## SPECIAL MEETING AGENDA

#### A. W1611-1- Application of J.E. Shepard Company and Capstone Collegiate Communities-Construction of a 358-Unit Multi-family Development-1621 Storrs Road and Middle Turnpike (Assessor Parcel IDs 9.23.1, 9.23.7 and 9.23.8)

[W1611-1 LandTech 1621 Storrs Rd review 2-13-2020](#)

Re: Response to Mansfield Inland Wetlands Application Review  
Residential Development  
1621 Storrs Road & Middle Turnpike  
Mansfield, CT

**VERTICAL AMPHIBIAN BARRIER AMX 40 / 1015 WILD LIFE FENCE**

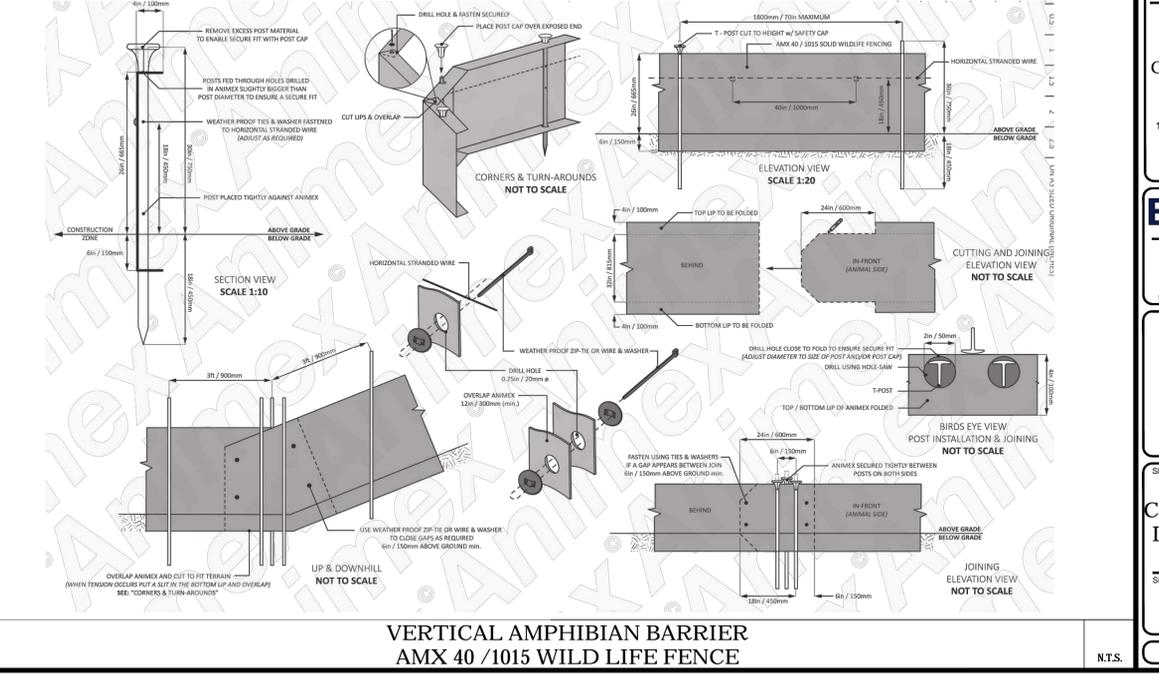
12. A call-out for a "critter wall" is noted on sheet 5 of 24 and a detail of this "critter wall" is shown on sheet 23 as a detail called "Vertical Amphibian Barrier." Per sheet 5, this critter wall appears to encircle the entire envelope of the limits of disturbance. The detail for the "critter wall" on sheet 23 shows the wall to be comprised of a 6-inch wide and 24-inch tall concrete block buried approximately 12 inches into the soil. The above grade 12 inches of the block will face away from the development and will be backfilled on the development side. A small detail within the block shows a measurement of "Varies 0"-12" depicting how far the block extends out of the ground. This "critter wall" is

a new feature added to the current submission. It is not a sufficient attempt to keep the vernal pool dependent amphibian species from entering the development for the following reasons:
